**PLANNING COMMISSION REPORT
NON-PUBLIC HEARING ITEM
REGULAR AGENDA
PUBLIC HEARING ON THE VARIANCE ONLY**

PC Staff Report
1/25/12

ITEM NO. 10B PRELIMINARY PLAT FOR ASPEN HEIGHTS ADDITION; 1900 W 31ST ST (SLD)

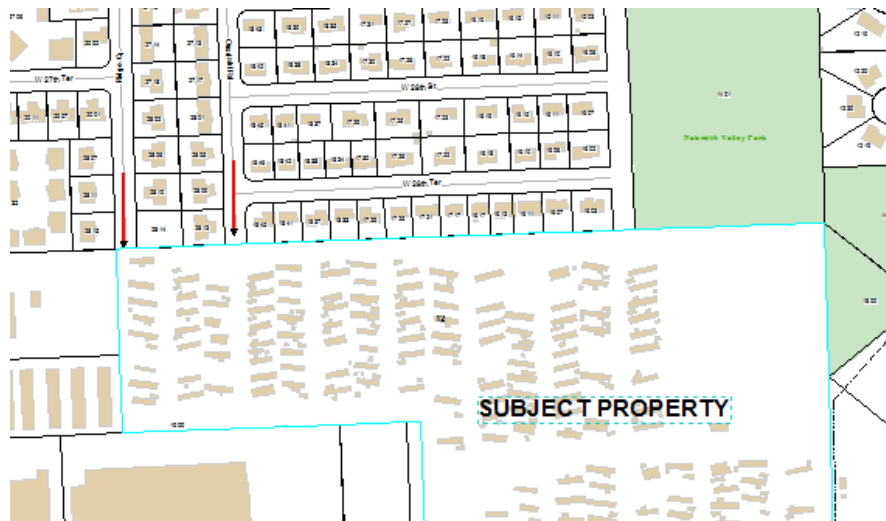
Rights-of-Way: Section 20-810 of the Subdivision Regulations provides the design standards for streets. 31st Street is a designated principal arterial street. Ousdahl Road is a local street. A Principal Arterial Street requires a minimum width of 150' of Right-of-way. This is achieved by each abutting property dedicating one-half of the right of way (75'). The existing 31st Street right-of-way along the subject property includes 75' on the south side and only 50' on the north side.

The preliminary plat shows a total of 65' of right-of-way proposed and 15' of additional utility/pedestrian easement for a combined area of 80' for 31st Street. This combined with the existing

75' of right-of-way south of the center line is equal to 155' ROW/Easement to accommodate public improvements in this segment of 31st Street. A variance is required since the proposed right-of-way is less than the minimum 75' required by the Subdivision Regulations.

STAFF RECOMMENDATION: Staff recommends approval of the variance request from Section 20-810(d)(4) which requires a minimum of 150' of right-of-way for principal arterial streets. The variance would permit the following variation from the minimum required right-of-way from 75' to 65'.

1. Revision of the preliminary plat with the following notes and changes:
 - a. Addition of the following note to the face of the drawing: "Variance approved from Section 20-810(d) which requires a minimum of 75' to 65' for 31st Street."
2. Execution of an agreement not to protest the formation of a benefit district for future signalization and intersection improvements at Louisiana and 31st Streets executed by the property owner and provided to the Planning Office with submission of the Final Plat subject to the review by the City Attorney's Office prior to recording.
3. Execution of an agreement not to protest the formation of a benefit district for future street improvements to W 31st Street executed by the property owner and provided to the Planning Office with submission of the Final Plat subject to the review by the City Attorney's Office prior to recording.
